MINOR VARIANCE REPORT

APPLICATION: CAV A/066/2024 RELATED FILE: N/A

CAV A/066/2024 – 2092 Duncan Road (East District) (OP Designation: Low Density Residential)

Street View of subject lands - 2092 Duncan Road and the neighbouring dwellings abutting the

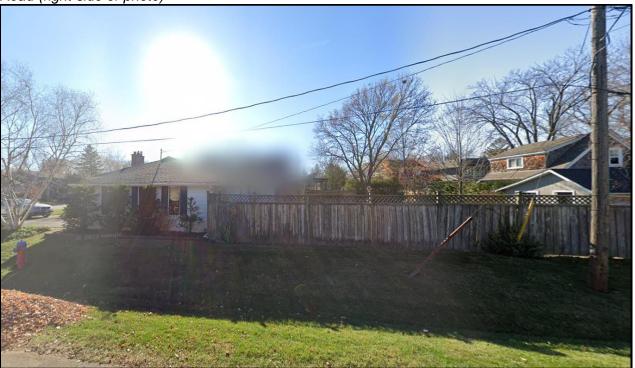
The subject property is located on the east side of Duncan Road, south of Constance Drive and backs onto Joshua Creek. A portion of the property is located within Conservation Halton's regulation limits. The neighbourhood consists of original one-storey, one-and-a-half storey, and two-storey dwellings with both attached and rear detached garages, along with a few newer two-storey dwellings. The existing and proposed dwellings can be viewed in the images below.
